#### PLANNING COMMISSION WORKSHOP AGENDA

Wednesday, December 20, 2023 | 3:00 p.m.
Planning & Building Dept. Conference Room – 196 Laurel Street

**PIN: 368-07-01-0101** (**Lot 90, Rollingson Subdivision**) – The applicant, Jamie Steele, Diamond Shores. is requesting a design modification to allow for the issuance of a building permit on an existing lot of record that lacks frontage onto a publicly maintained street.

*Previously Deferred* ...Proposed Development Agreement by Lennar Carolinas, LLC and Thomas & Hutton, for proposed development of property located on Hwy 378, Juniper Bay Rd, and Dunn Shortcut Rd, to be known as the Tributary Planned Development, and consisting of approx. 486 +/- acres (PIN's 336-00-00-0043, -0044, -0045, 336-13-04-0006, 336-14-04-0011, 336-15-03-0003, 370-00-00-0011, 370-04-01-0004, 337-00-00-0009, -0011, -0012, and 337-08-01-0004).

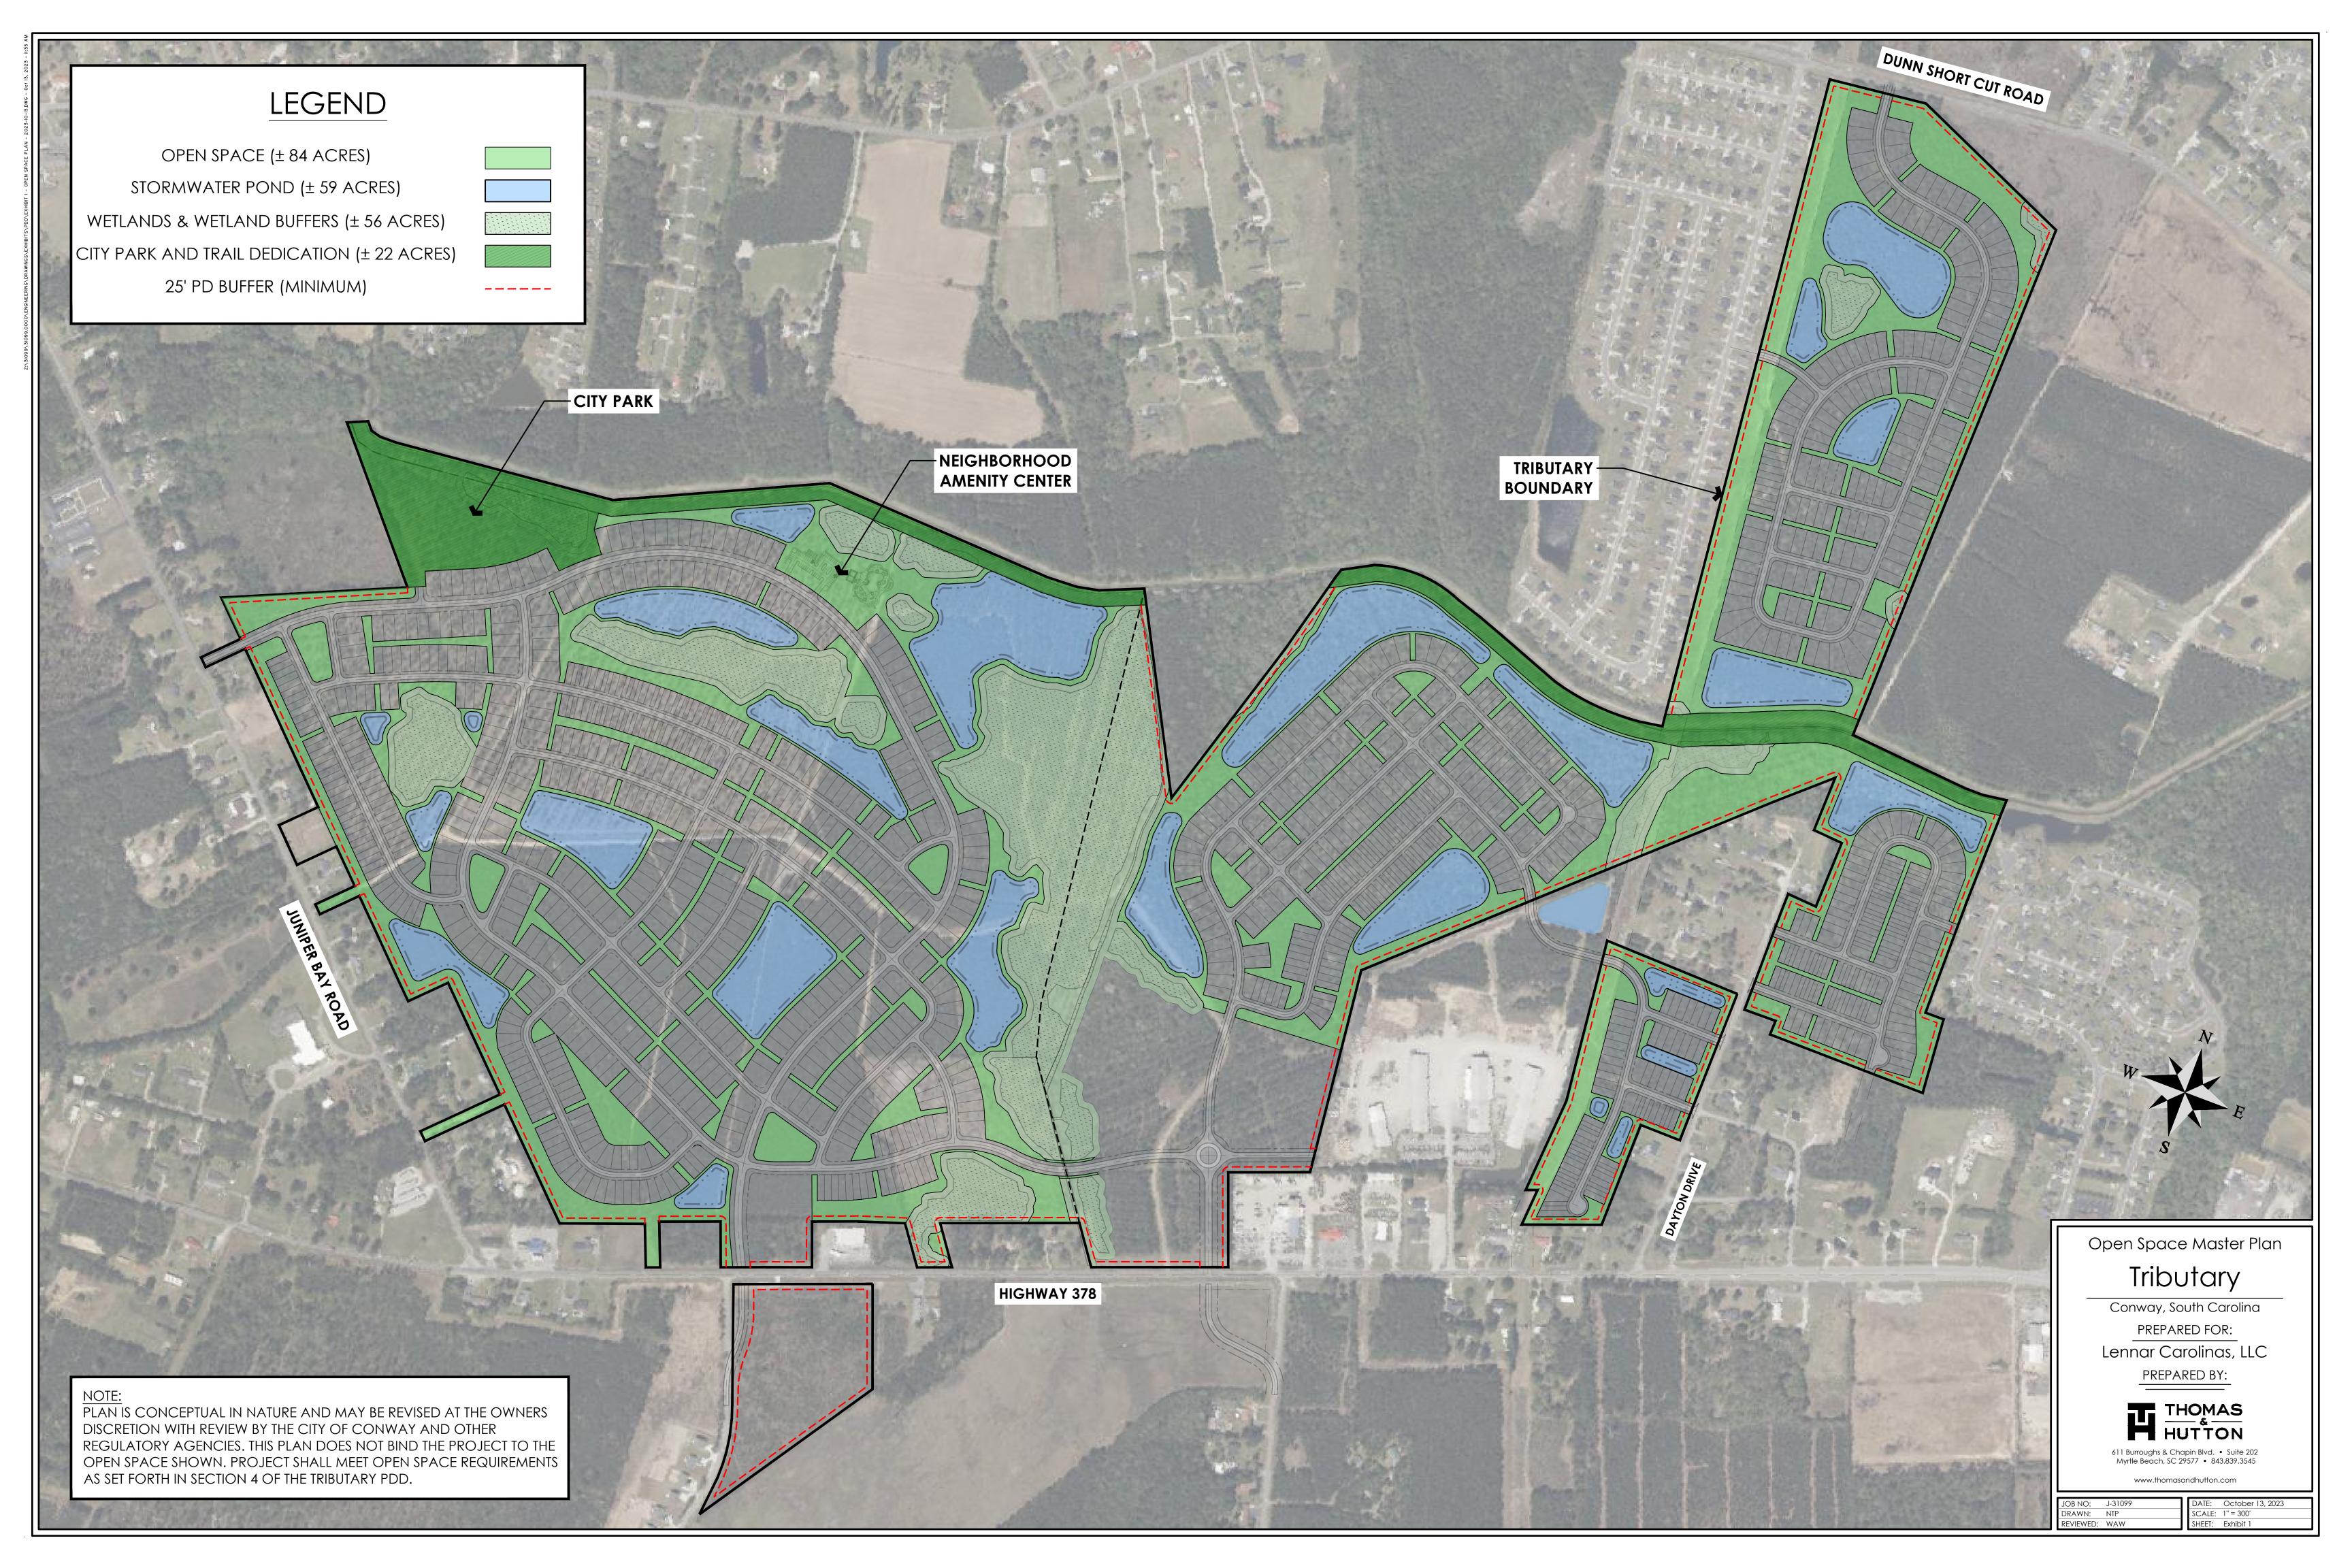
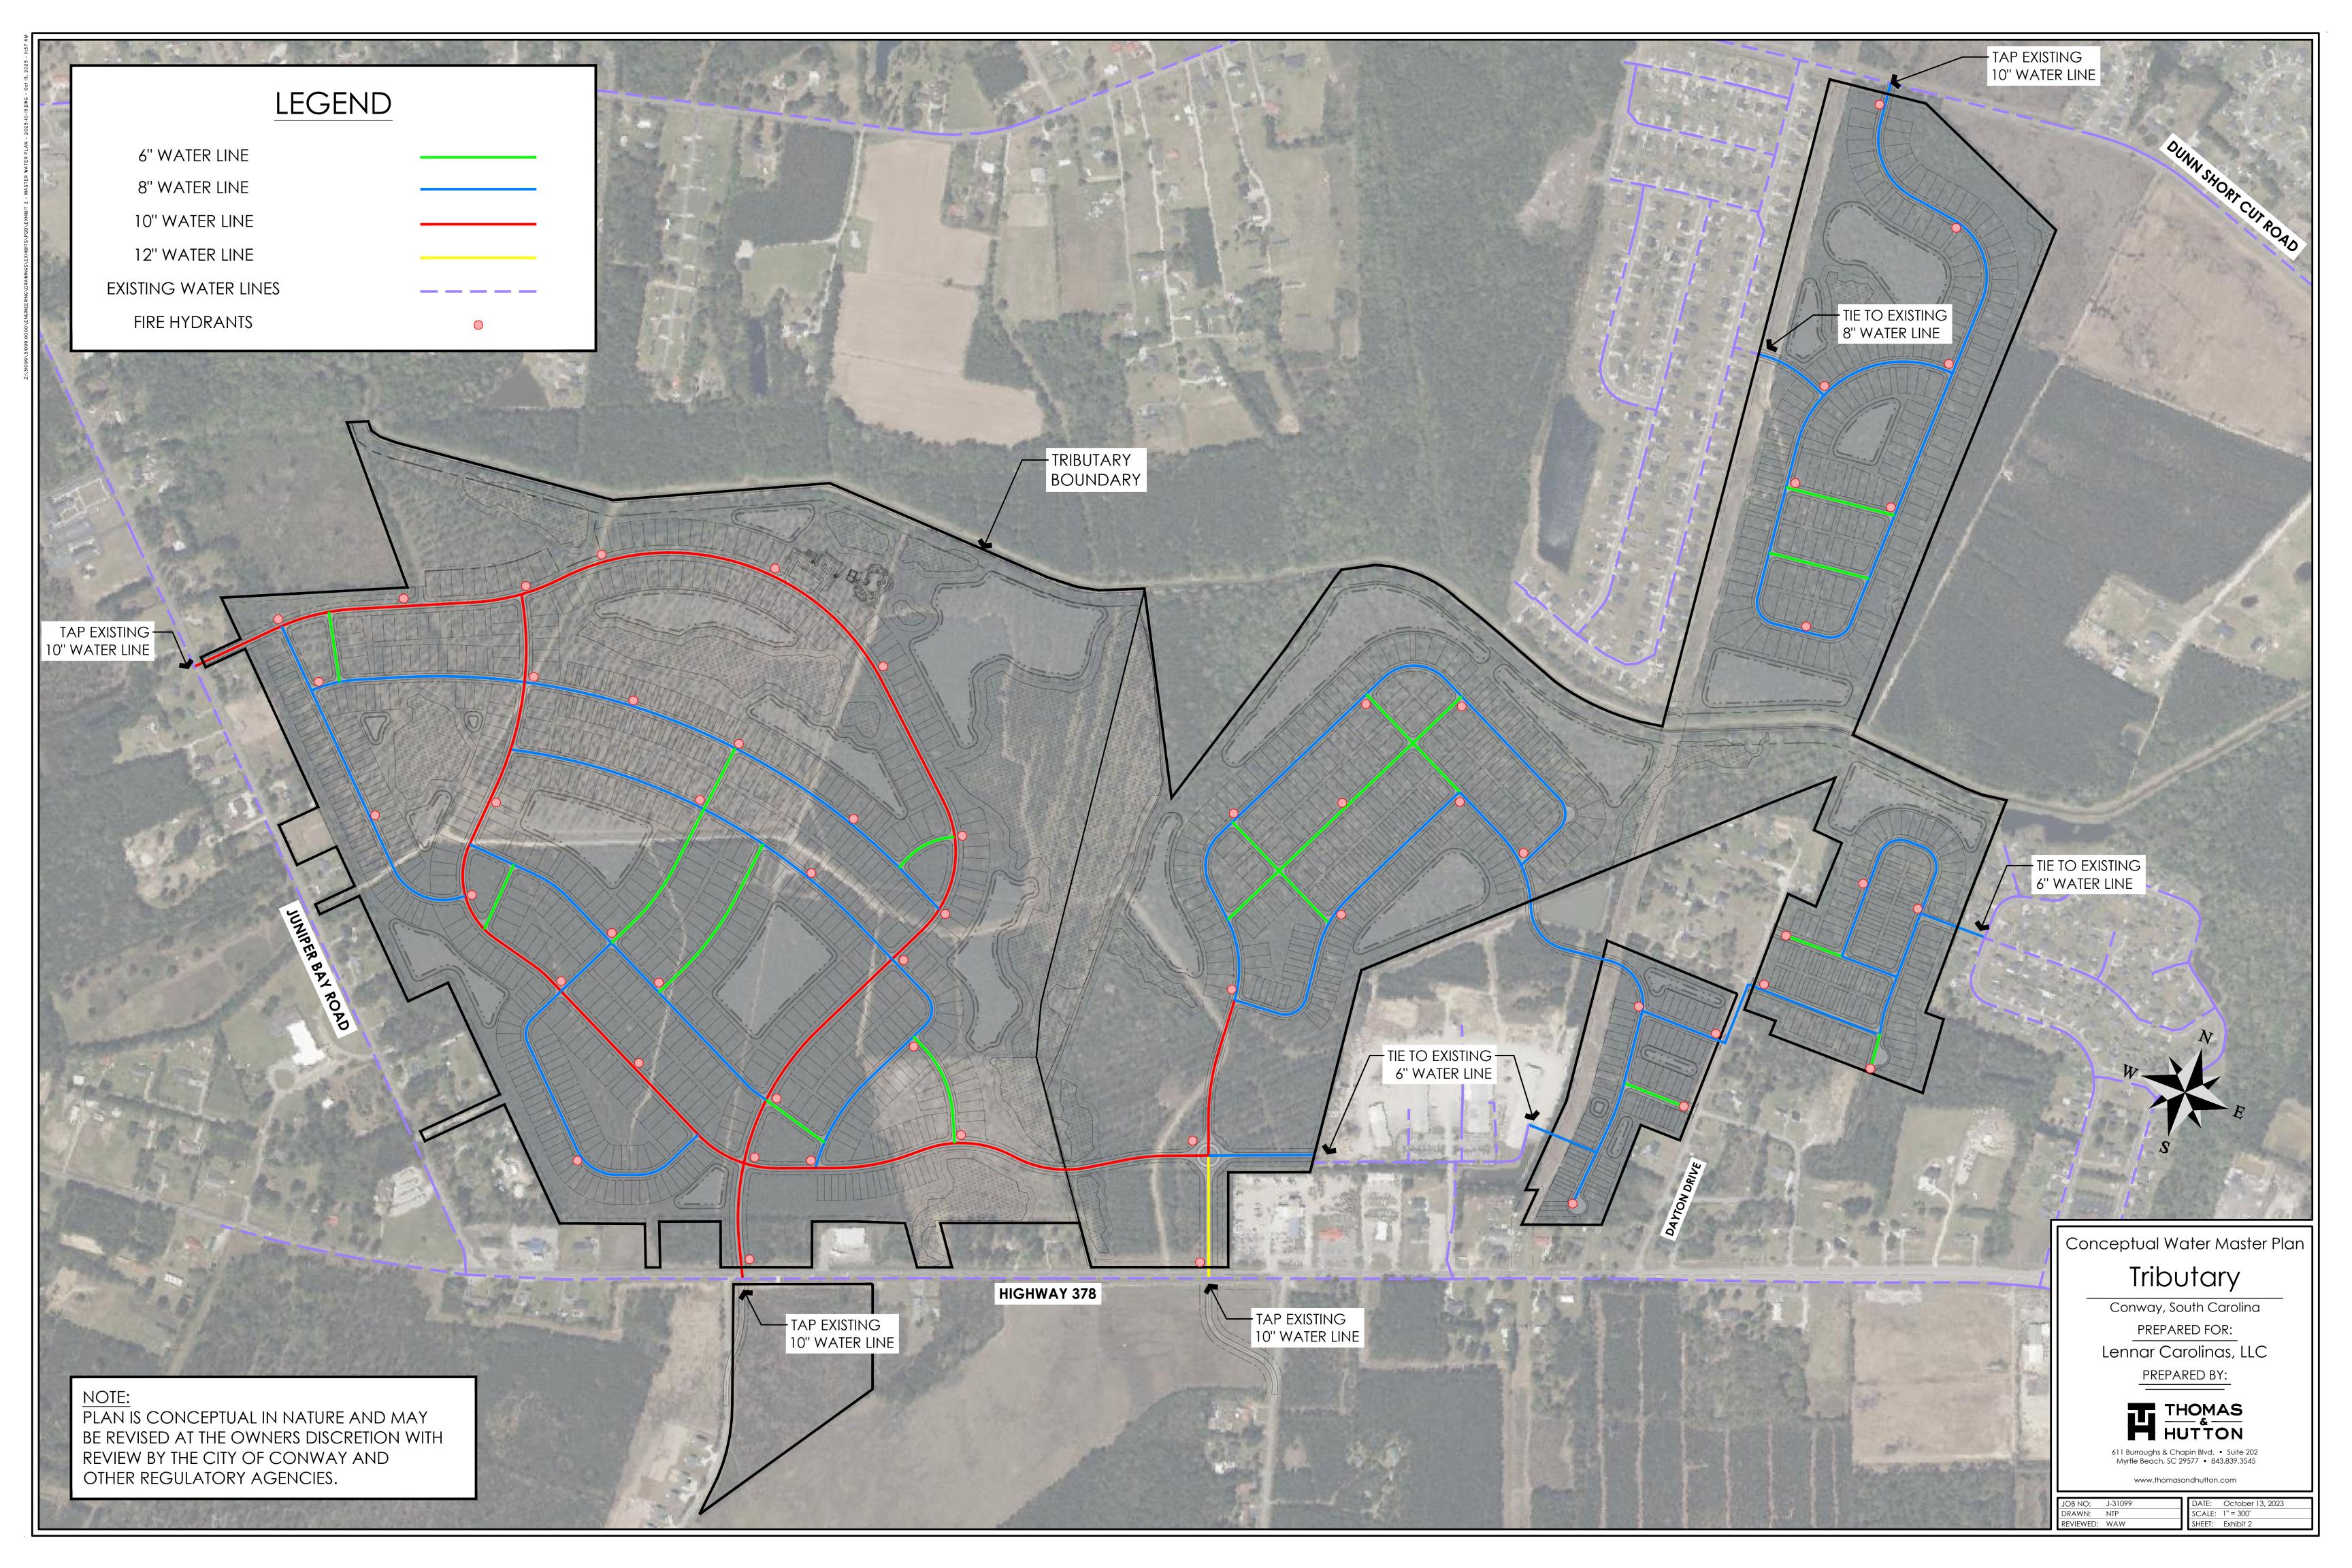
PD NARRATIVE COMMENTS			
PD Narrative Section	Issue	Additional Info / staff Comments	
Section 1: Purpose and Intent Statement	(pg. 4) Reference to nearby regional roadways: includes Highway 701 S, but not Highway 378. Is this intentional?		
Section 2: Development Summary	(pg. 4) 1 <sup>st</sup> paragraph: Remove reference to Sec. 6.4.2 of the UDO.	Just specify "in accordance with the City of Conway UDO"	
	(pg. 4) 3 <sup>rd</sup> paragraph: "transfer of units between districts"	should this be tracts or phases instead?	
	(pg. 4) 3 <sup>rd</sup> paragraph: transfer of units between tracts	The flex tracts proposing multifamily should not be included in the transfer of densities between like tracts. This should be restricted between the "R" tracts.	
	(pg. 4) 3 <sup>rd</sup> paragraph: "use districts shall be capped at 125% pf the density shown in the development summary table"	Staff would prefer that the wording be revised to state something similar to "density may be shifted between tracts with like uses, provided that the <b>overall</b> density across the entire PD/across all tracts is not increased"

(pg. 5) Use District column: Flex District F-1 and Flex District F-2.	Type column: only multifamily or townhome is listed. Shouldn't this include commercial as well?	
Development Summary Table	(pg. 5) Use District column: Commercial C-1 and Commercial C-2	Type column: shouldn't Light Industrial (LI) be added also?	
Section 3: Permitted Uses and Dimensional Requirements			
Dimensional Standards		Staff comment: Lot widths are very dense for this area (20' to 52' lot width, which vary throughout the project area)	
Section 4: Additional Requirements	(pg. 8) 7.A.: remove reference to Section 10.3.9	remove "Section 10.3.9" from sentence.

throughout the PD	(pg. 9)		Will the buffer be
District	8. Landscape Buffers and	PD External Perimeter Buffer	increased to 50' where
District	Quantities		adjacent to existing,
	Quantities		adjacent residential
			properties, as previously
			discussed?
			aiscussea?
			Remove reference to
		Footnotes 1 and 2	specific section of UDO

(6.5.2)
Section 5: Design	1. Landscape buffers between		
Standards and	commercial uses shall not be	Which tracts will these be applical	hle to?
Modifications	required.	Willest tracts will these be applical	ole to:

(p. 10)			
(β. 10)	2. Where multi-purpose trails are parallel to and within		
	·	These locations should be illustrat	ed on an exhibit (i.e.
	required landscape buffers, the	street framework plan)	
	width shall be reduced to a Type		
	A buffer.

(p. 11)	timing of such conveyance,	case includes areas being conveyed to the City will include,	
	installation of improvements,	should be installed and usable by residents within a	
	dedication, etc., shall be	development.	
	negotiated between the	development.	
	developer and City Council.		
	TRAFFIC IMPROVEM	ENTS (ON SITE & OFF-SITE)	
ONSITE (w/ in	Local Road (see exhibit and the	50' right-of-way (ROW); however, each lane is only	
project area)	Street Framework Plan)	proposed to be 11' in width, making the pavement width a	
		total of 22', with 2' curb/gutter, 6' shoulder/planting strip,	
		an 8' multi-use path on one side of roadway, and 5'	
		concrete sidewalk on other side of road. The minimum	
		pavement width should be 24'.	
	Minor Collector Road (see	60' ROW with 24' pavement width (12' each side), 2'	
	exhibit and the Street	curb/gutter, 6' shoulder/planting strip on each side of road,	
	Framework Plan)	an 8' multi-use path on one side of roadway and 5' concrete

Flamework Flam	sidewalk on other side of road.	
	Callanta a Band		
	Collector Road	70' ROW with 28' wide pavement width, 2' curb/gutter, 8'	
		shoulder/planting strip on both sides, an 8' multi-use path	
		on one side and 5' sidewalk on the other side of the road.	
	Entrance Road (collector)	90' ROW with median (24' pavement width on one side of	
		median and 14' pavement width on other side of median),	
		2' curb/gutter, 8' shoulder/planting area on each side of	
		road, 8' multi-use path on one side of roadway and 5'	
		concrete sidewalk on other side of road.	
	Dayton Drive (variable width)	Dayton appears to be an approx. 50' ROW at the point in	
		which tracts R-3 and R-4 will be accessed; however, the	
		entrance to Dayton from Hwy 378 is smaller – approx. 30' in	
		width, and in order for the project to be compliant with	
		roadway standards of the UDO, the entire roadway (Dayton	
		Dr) must come into compliance. The applicant may have to
